**15-DAY EXPRESS TERMS  
FOR  
PROPOSED BUILDING STANDARDS  
OF THE  
OFFICE OF THE STATE FIRE MARSHAL

REGARDING PROPOSED CHANGES TO  
2016 CALIFORNIA RESIDENTIAL CODE  
CALIFORNIA CODE OF REGULATIONS, TITLE 24, PART 2.5**

**CHAPTER 44  
REFERENCED STANDARDS**

~~FIGURE 11.2.3.2.3.1 Design Area Reduction for Quick-Response Sprinklers~~

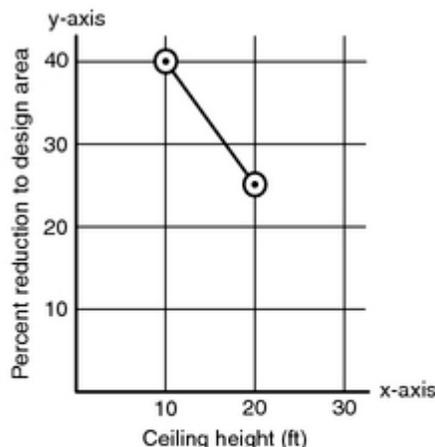
~~11.2.3.1.4(4)~~11.2.3.1.5.2(9) Exterior columns under 10 ft<sup>2</sup> (0.93m<sup>2</sup>) in total area, formed by studs or wood joist, with no sources of ignition within the column, supporting exterior canopies that are fully protected with a sprinkler system.

Note:  $y = \frac{-3x}{2} + 55$

For ceiling height  $\geq 10$  ft and  $\leq 20$  ft,  $y = \frac{-3x}{2} + 55$

For ceiling height  $< 10$  ft,  $y = 40$

For ceiling height  $> 20$ ,  $y = 0$
